E8362A-02

S E R V I C E N O T E

E8362A PNA Microwave Network Analyzers

Figure 1: A3 Front Panel Interface Board Assy without the Bracket

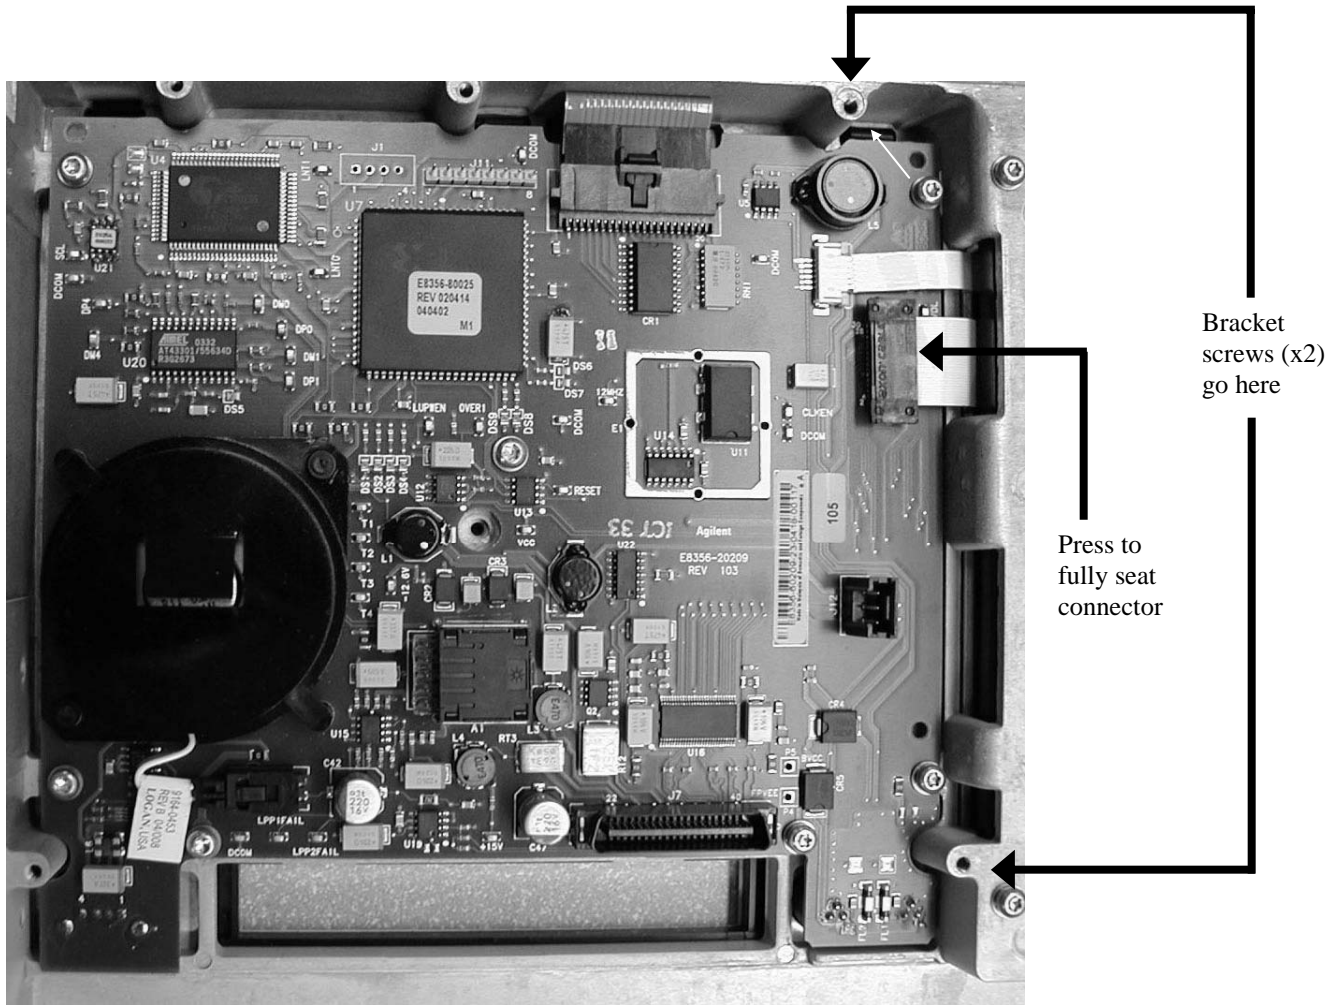
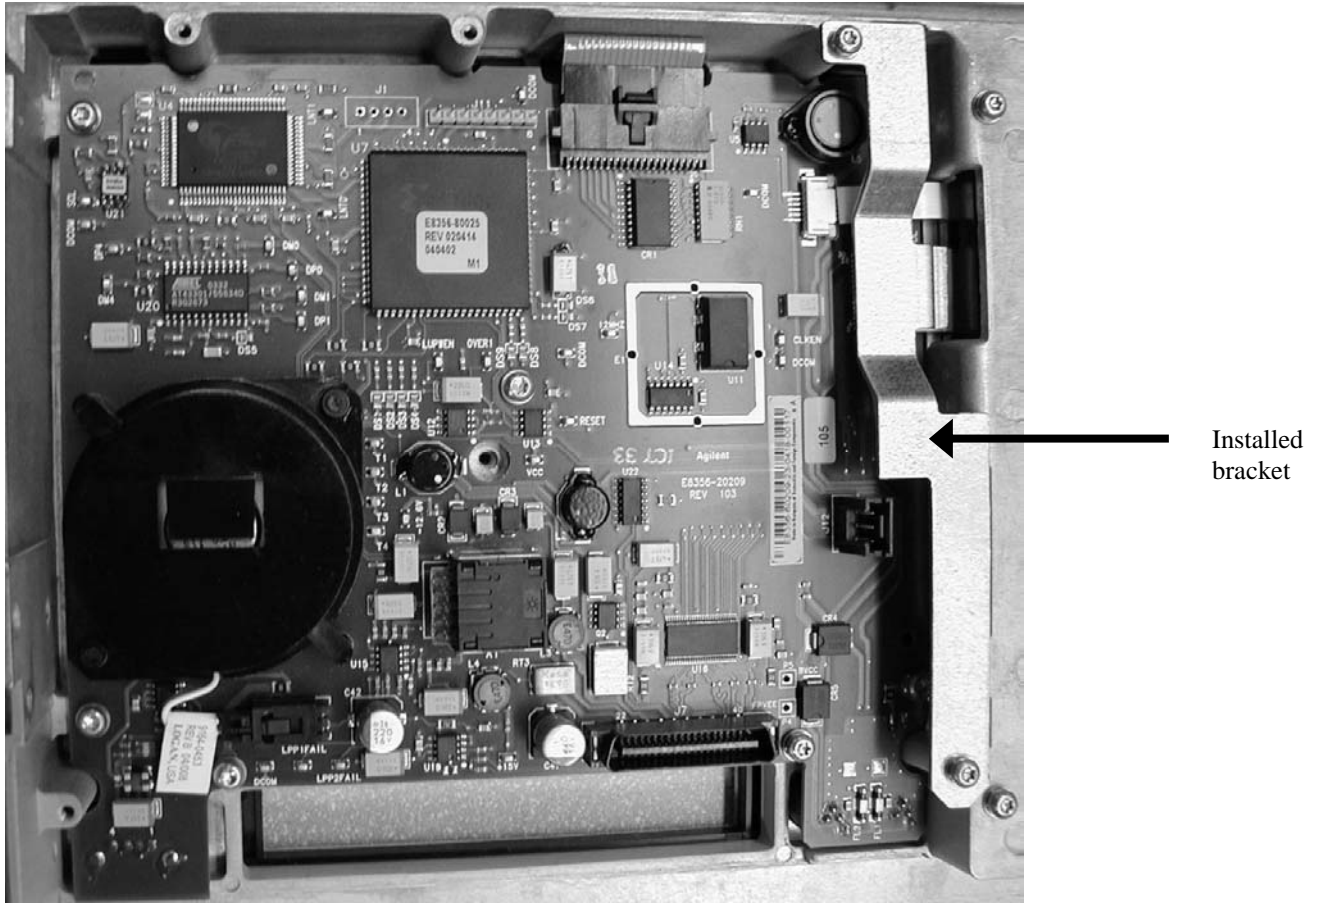
A connector of the ribbon cable (Agilent part number 8120-8409) that joins the front panel display to the front panel interface board can loosen, causing a display failure, unless a new bracket is installed. Because the failure rate has been very low, it is recommended that the bracket be installed only when there is an additional reason to remove the PNA front panel.

1. Refer to Figure 1 in this document:
 - Press down firmly on the ribbon cable's black connector.
 - Locate the two tapped holes for the bracket screws.
2. As shown in Figure 2 in this document, position the bracket so that its holes line-up with the two holes you located in the previous step.
3. Hand-start the two screws, and then torque both to 9 in-lbs.
4. Reinstall the PNA Front Panel by following the Service Guide instructions in the "Replacement Procedure." This is located on the same page as the "Removal Procedure" used previously in step 7.
